ST. CHRISTOPHER'S SQUARE: APPLICATION NUMBER 22/01221/F OBJECTION TO THE REVISED PROPOSALS FROM WESTBURY PARK COMMUNITY ASSOCIATION (WPCA)

This submission from the WPCA sets out our objections to the submitted revisions to planning application 22/01221/F.

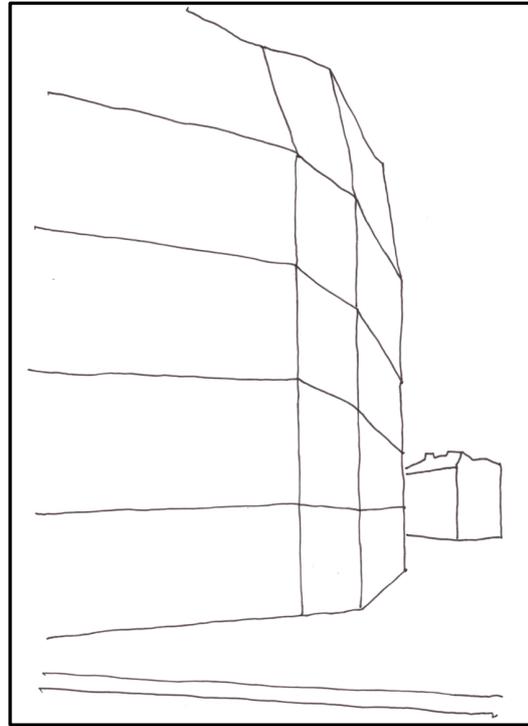
2. There is clearly an attempt to try to secure support for the new Villas by constantly referring to design details from Westbury Park (the street) rather than – as we believe should be the case for the backland area - from the houses in Royal Albert Road, Bayswater Avenue, The Glen and Blenheim Road.
3. The design changes are based on formal elevations, which is not how people experience buildings when walking along.

We object to the applicant's use of selective design references in a forlorn attempt to ameliorate the impact of the proposed overdevelopment of the site.
